Univent Replacement at Farley Elementary School
Univent Replacement at Willow Grove Elementary School
MSA File No. 42052

SED No. 50-02-01-06-0-003-011
SED No. 50-02-01-06-0-030-016

Re: ADDENDUM NO. 1

Drawing Title ELECTRICAL ROOF PLAN - 1	Drawing No. FES-E-104
--	---------------------------------

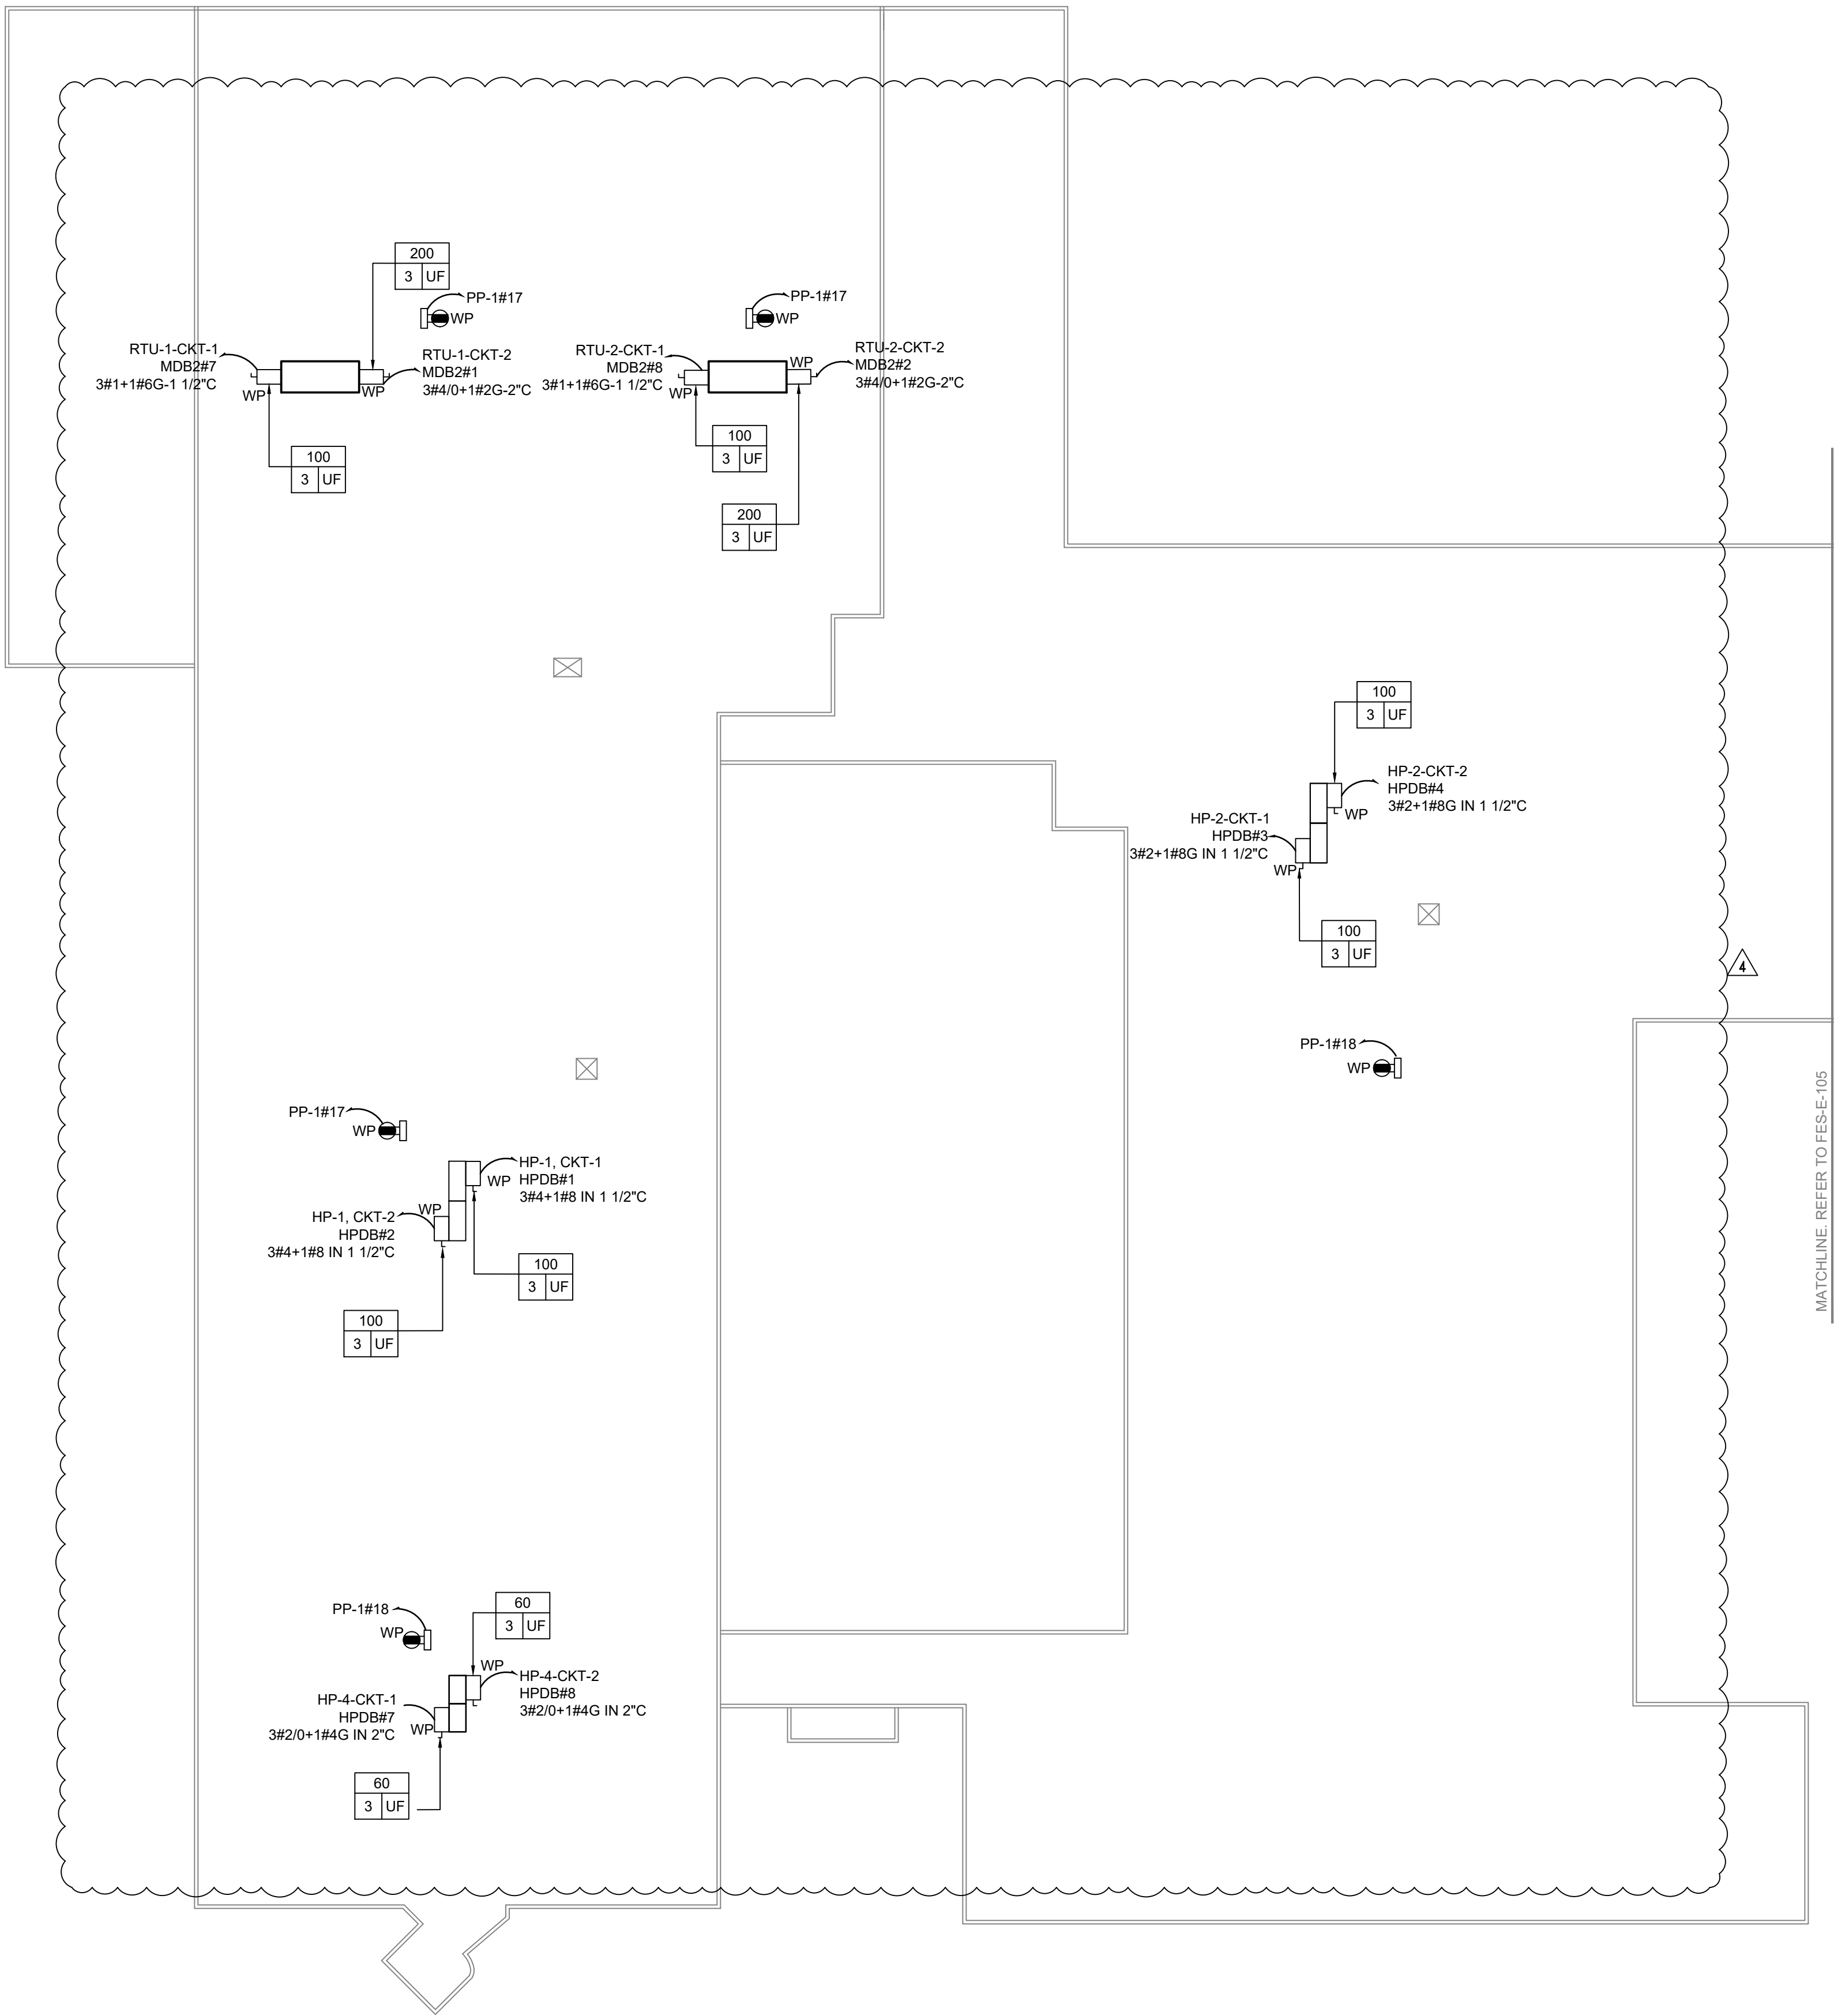
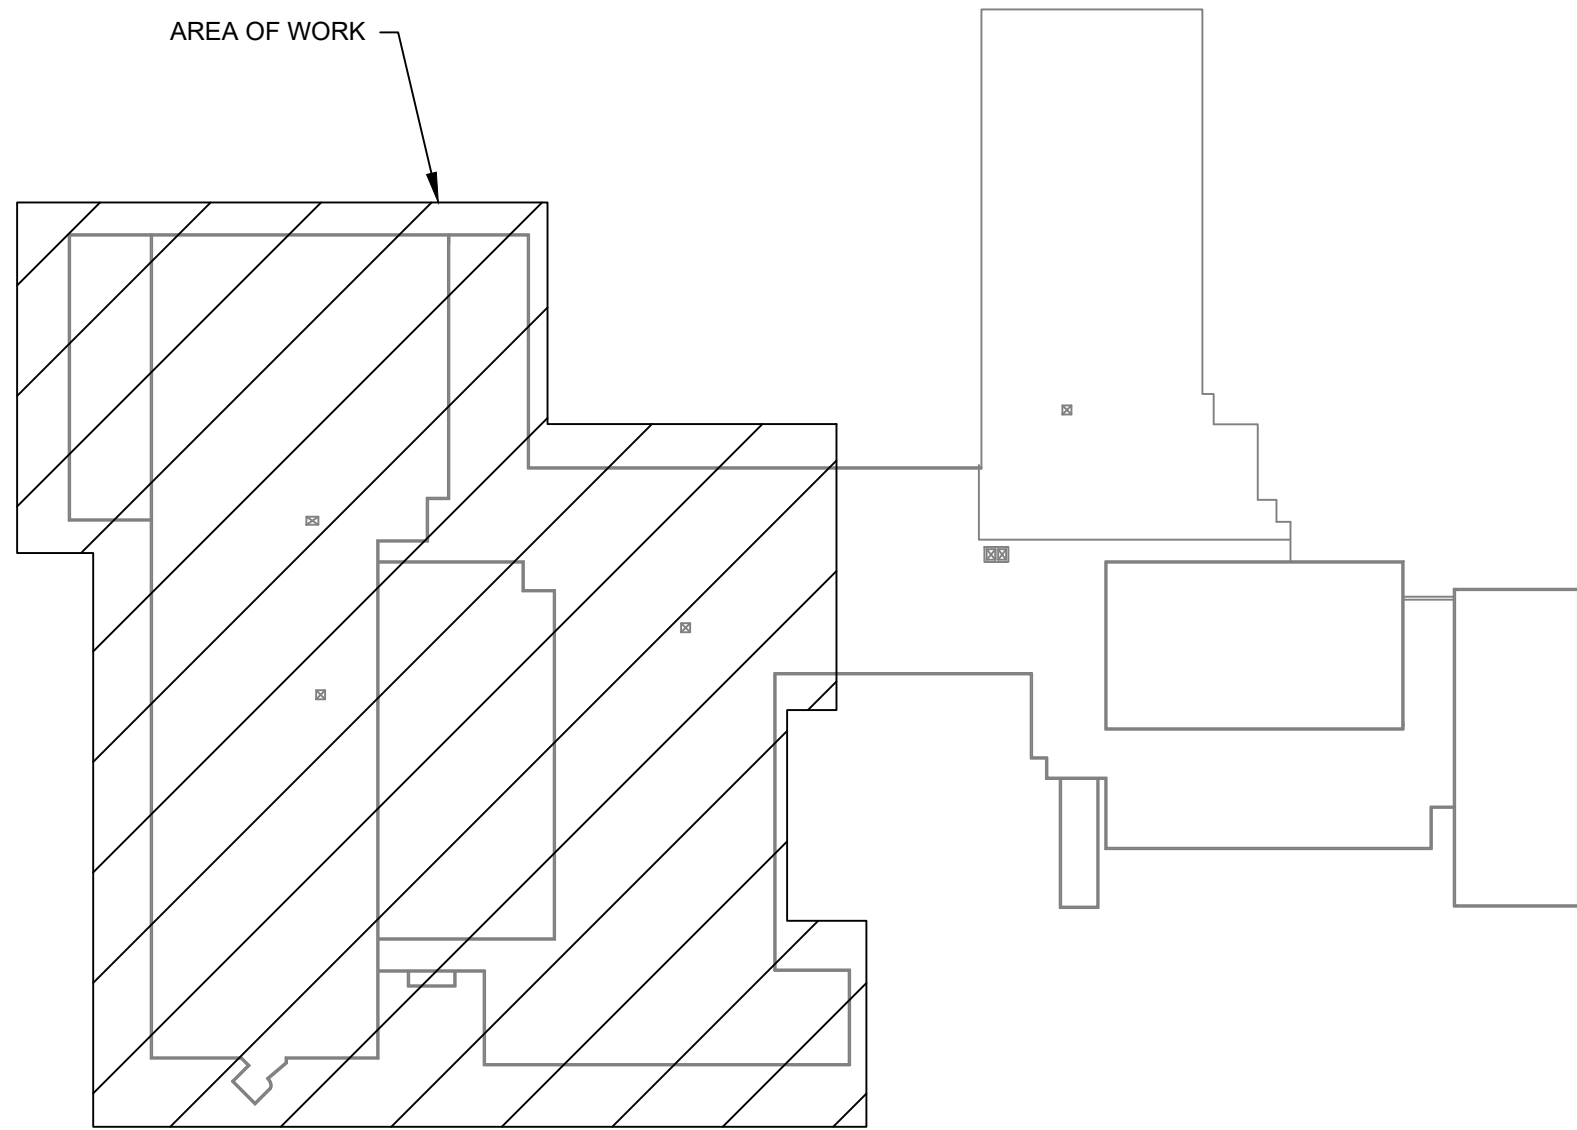
- 26) Drawing FES-E-102 has been revised dated, 11-09-23, see attached. Revisions include updates to the branch controller locations.
- 27) Drawing FES-E-104 has been revised dated, 11-09-23, see attached. Revisions include updates to the existing panel directories.

Drawing Title ELECTRICAL ROOF PLAN - 2	Drawing No. FES-E-105
--	---------------------------------

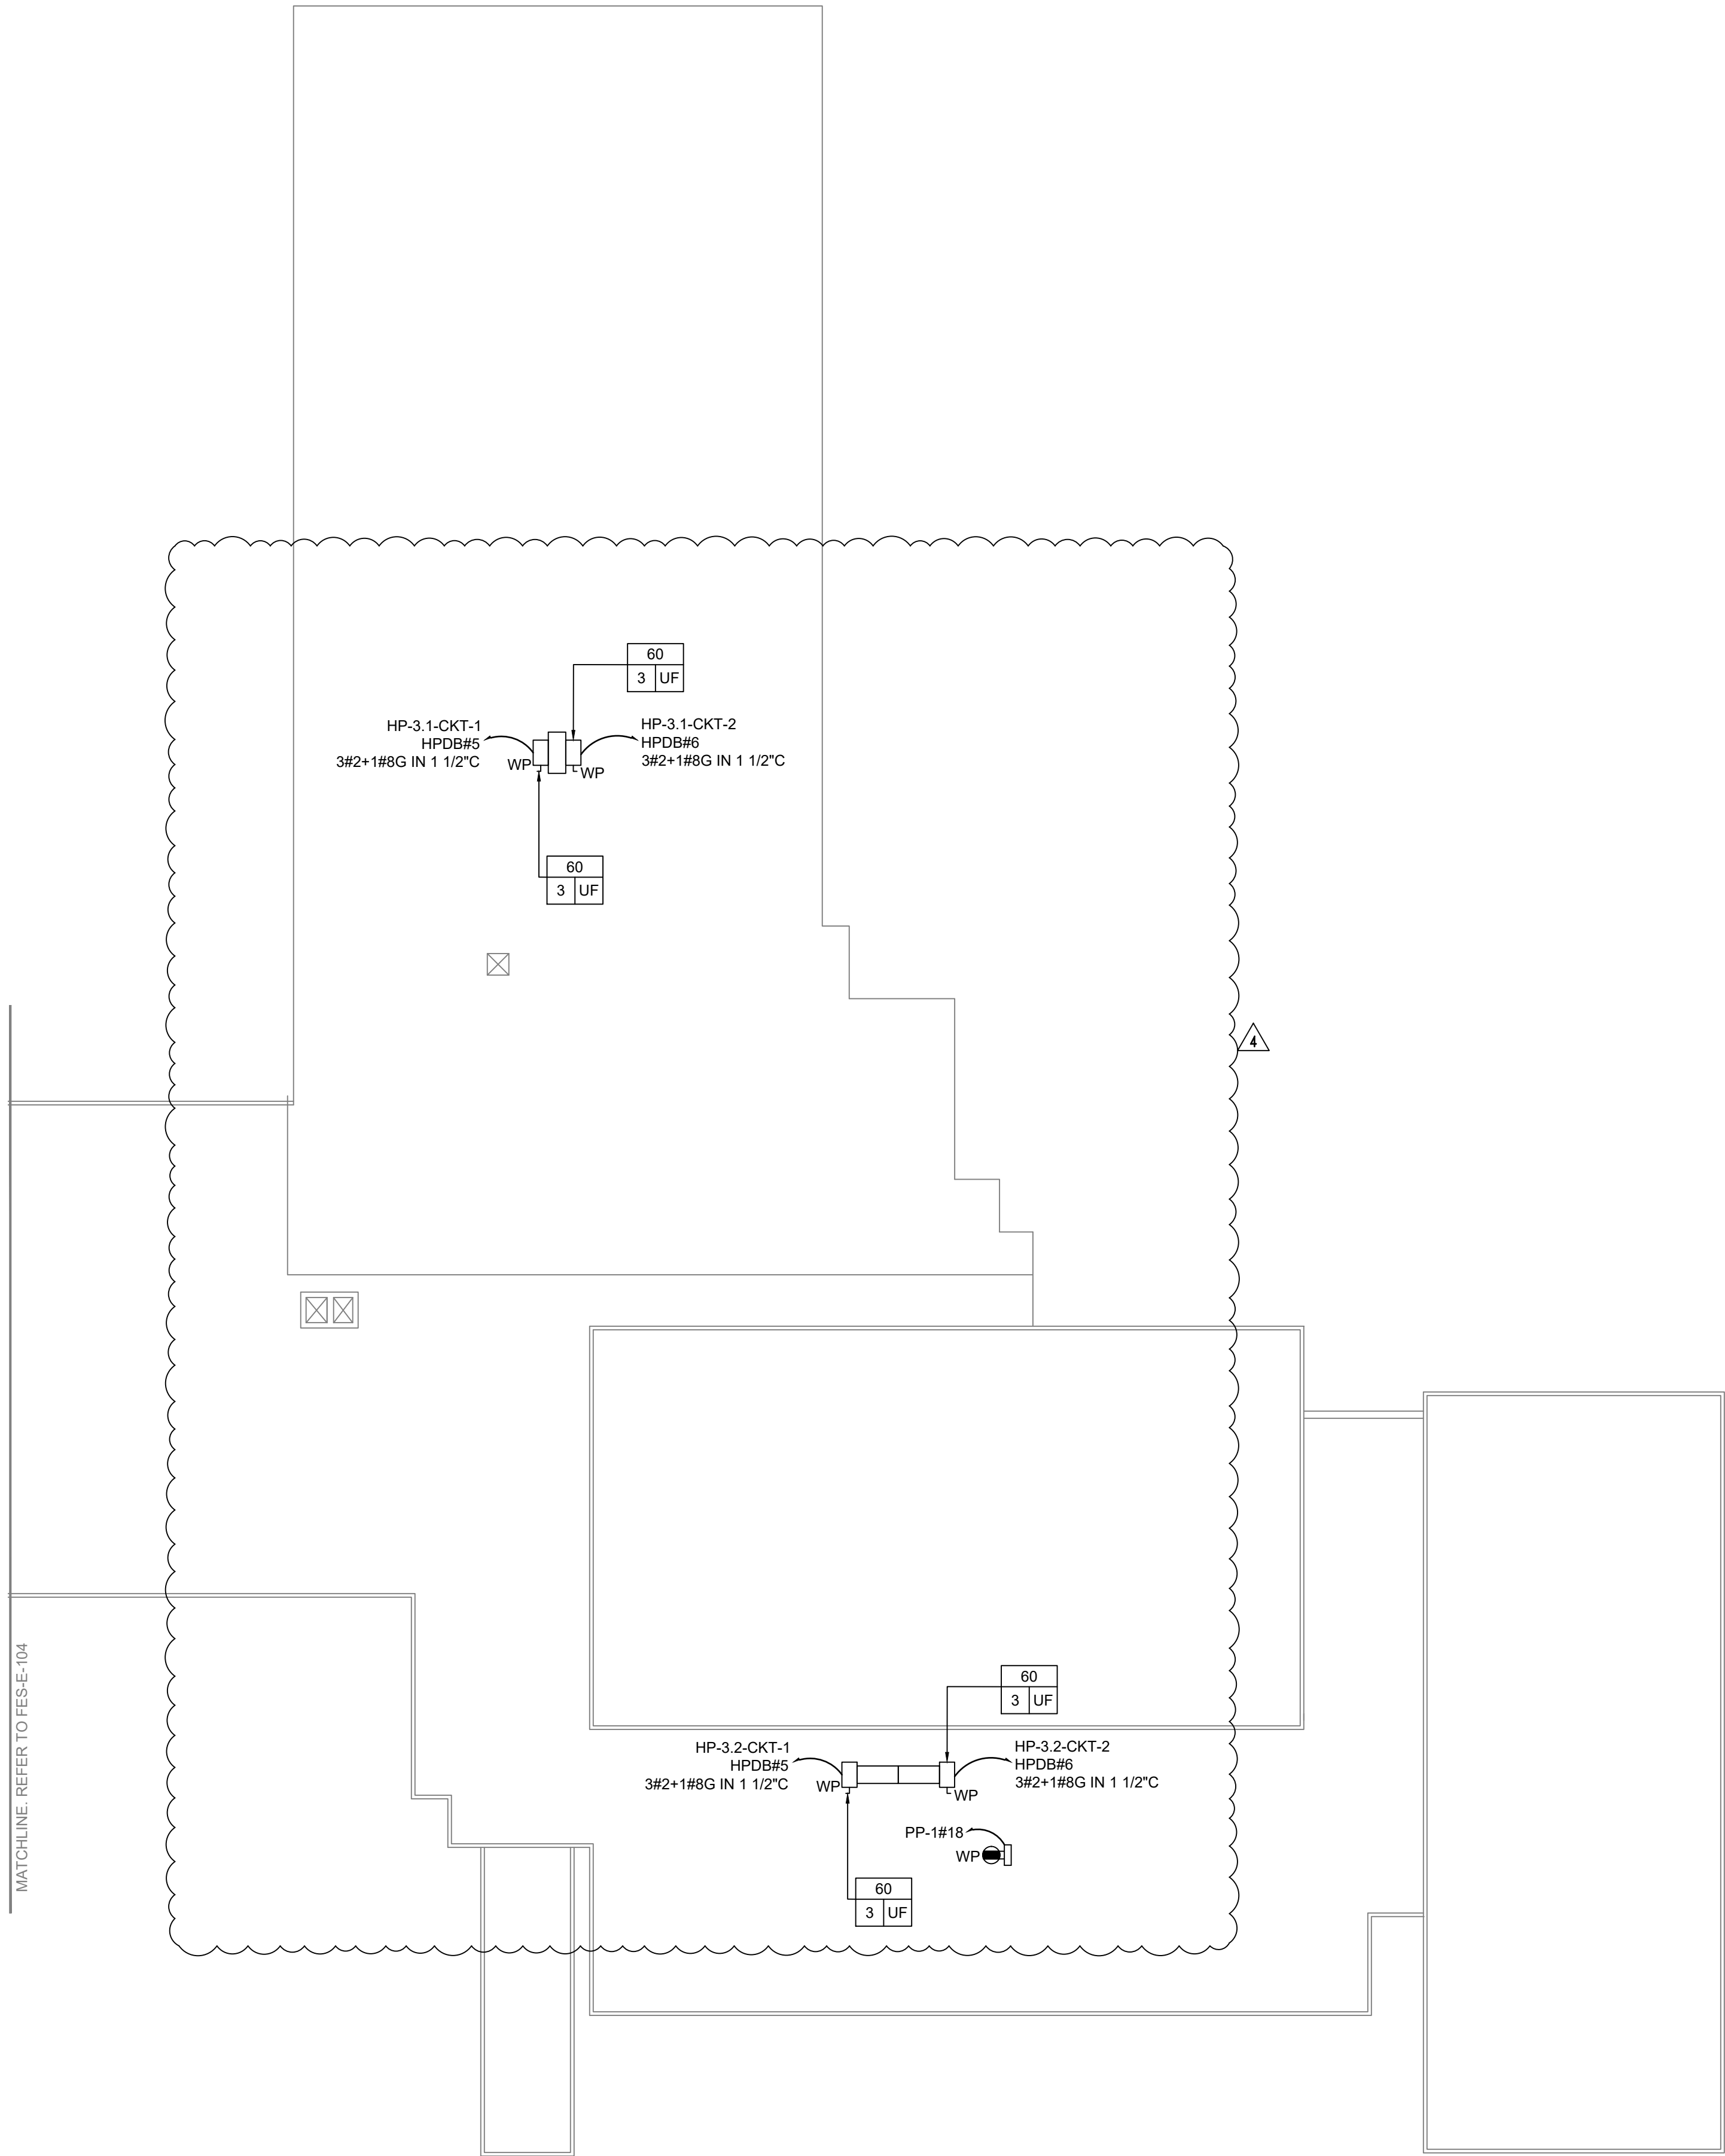
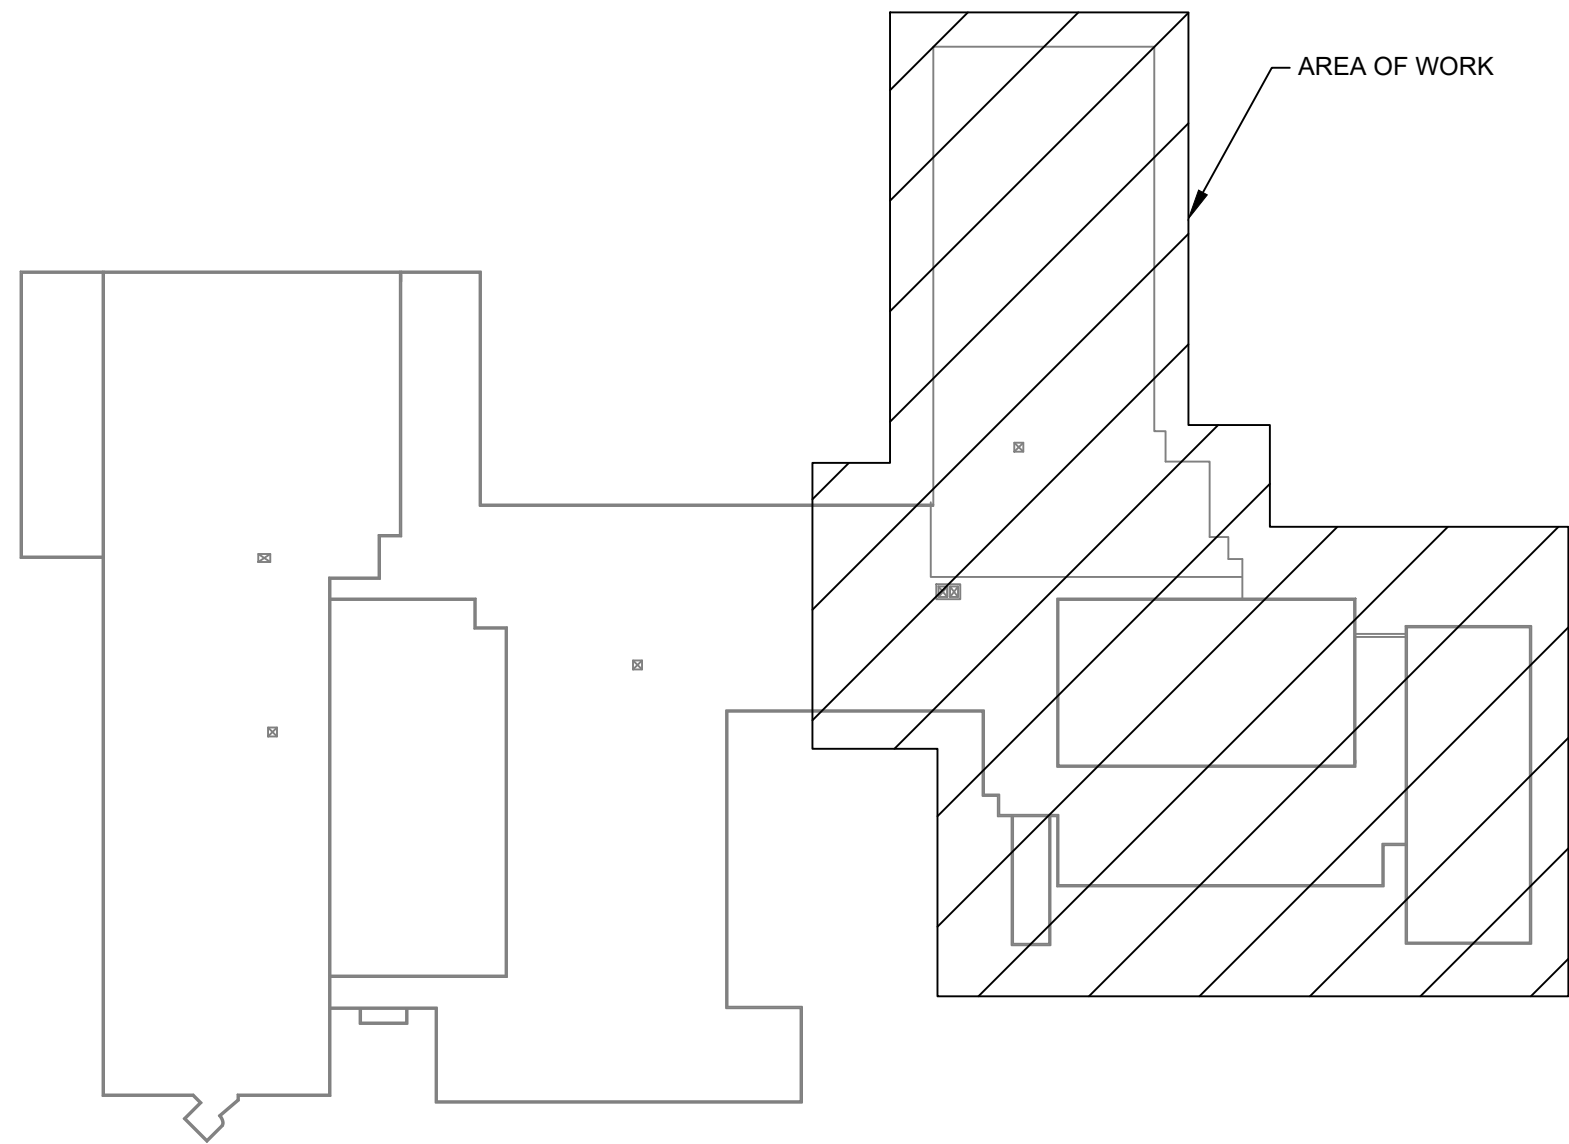
- 28) Drawing FES-E-105 has been revised dated, 11-09-23, see attached. Revisions include updates to the existing panel directories.
- 29) Drawing FES-E-400 has been revised dated, 11-09-23, see attached. Revisions include updates to the electrical one line diagram and schedule.
